**Project: 226052 DFCI-BIDMC New Cancer Hospital - 1 Joslin Place - Construction**
1 Joslin Place
Boston, Massachusetts 02215

# RFI #0-PB-125: Trap Primer & Trap Guard Confirmation

6 ELECTRONIC TRAP PRIMING ASSEMBLY DETAIL WITH AIR GAP FITTING

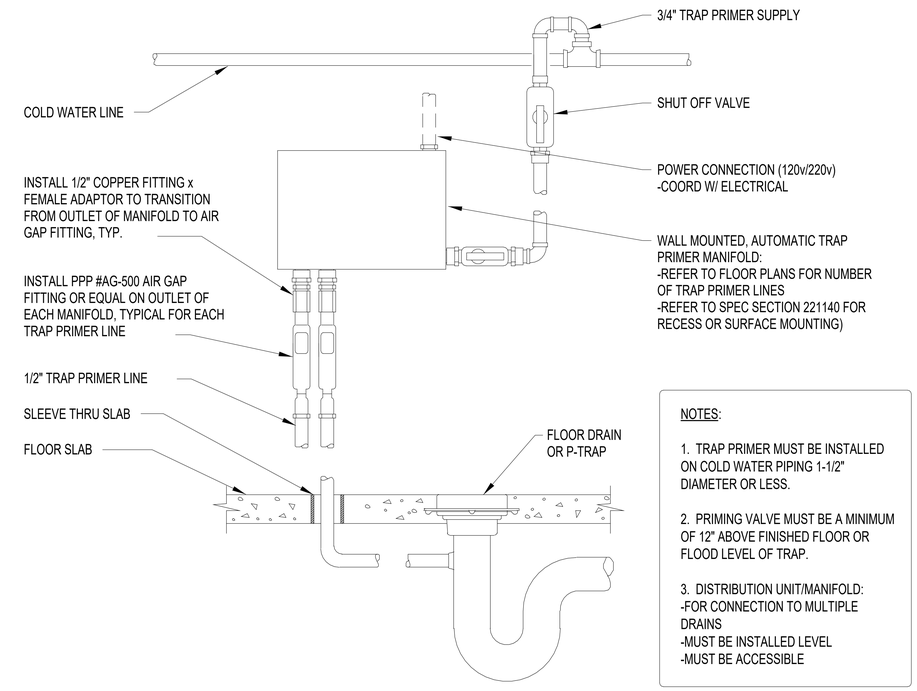
1. Per the 11/20/25 response to pre-bid RFI #58, all trap primers will be electronic type trap priming assemblies. The Trap Primer specifications were not updated with the Addendum 02 issue. Please confirm that electronic trap priming assemblies are the correct design standard.

2. Per the plumbing specifications, all garage drains are to receive a trap primer. This would result in significant costs to supply water for a trap primer at each garage drain. Please confirm if the 90-10 rule is acceptable at garage drains. This would mean that 90% of the garage drains in a single parking level would receive a trap guard, and 10% of the floor drains in a single room would receive a trap priming device.

6 ELECTRONIC TRAP PRIMING ASSEMBLY DETAIL WITH AIR GAP FITTING

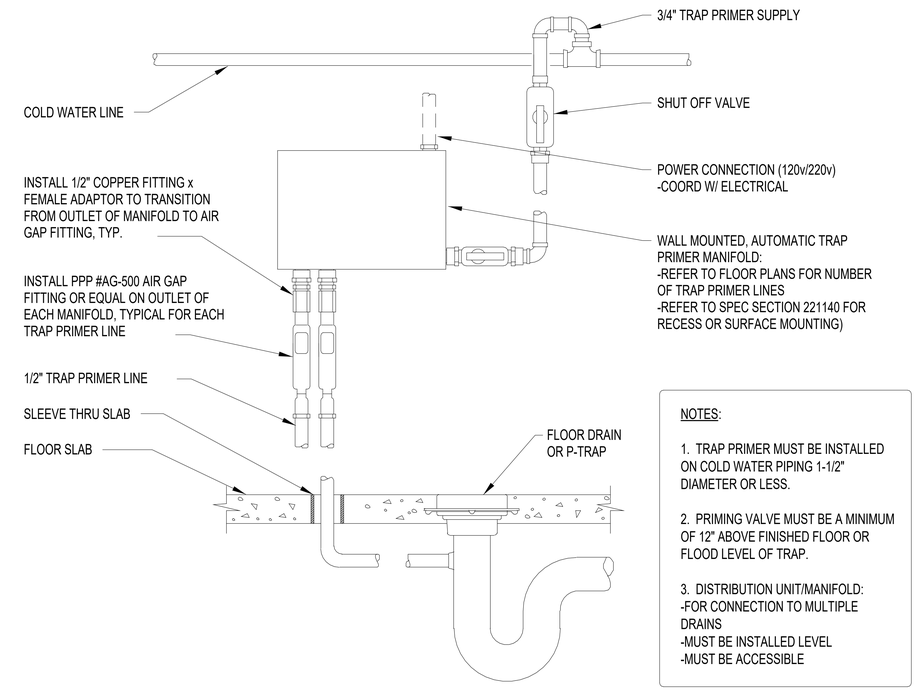
1. Per the 11/20/25 response to pre-bid RFI #58, all trap primers will be electronic type trap priming assemblies. The Trap Primer specifications were not updated with the Addendum 02 issue. Please confirm that electronic trap priming assemblies are the correct design standard.

2. Per the plumbing specifications, all garage drains are to receive a trap primer. This would result in significant costs to supply water for a trap primer at each garage drain. Please confirm if the 90-10 rule is acceptable at garage drains. This would mean that 90% of the garage drains in a single parking level would receive a trap guard, and 10% of the floor drains in a single room would receive a trap priming device.

1. Yes, electronic trap priming assemblies are the correct design standard. This has been re-confirmed with DFCI.
2. Per discussion with DFCI, the garage drains shall be primed by electronic trap primers. The primers are currently stacked and shall be supplied up & down from a cold water main on Level P3.
